PCN-20201004 TE0876-02 SPI Flash Change

Company	Trenz Electronic GmbH
PCN Number	PCN-20201004
Title	TE0876-02 SPI Flash Change
Subject	BOM change
Issue Date	2020-10-06

#1 Change SPI Flash from N25Q064A13ESE40F to IS25LP064D-JBLE

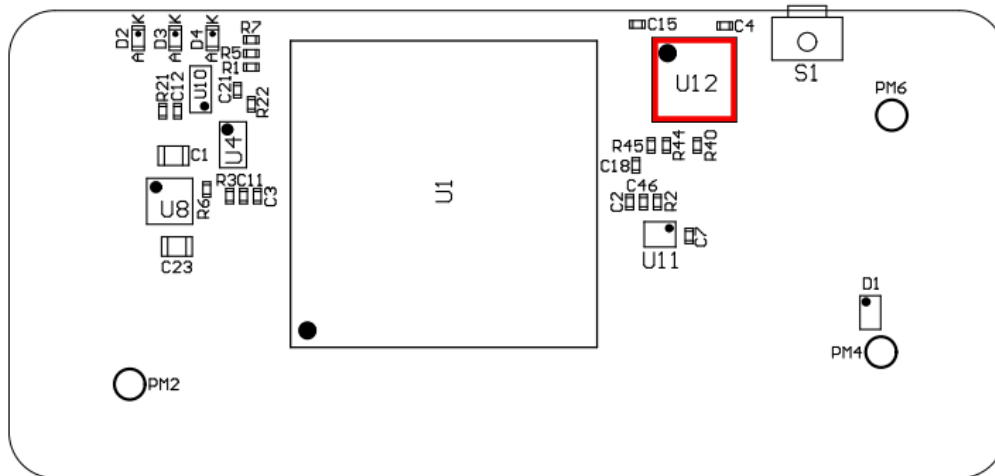
Type: BOM change

Reason: Old flash is obsolete.

Impact: JEDEC ID changes from BA17h to 6017h and manufacturer ID from 20h to 9Dh.

Locate Flash (U12) at top side of PCB:
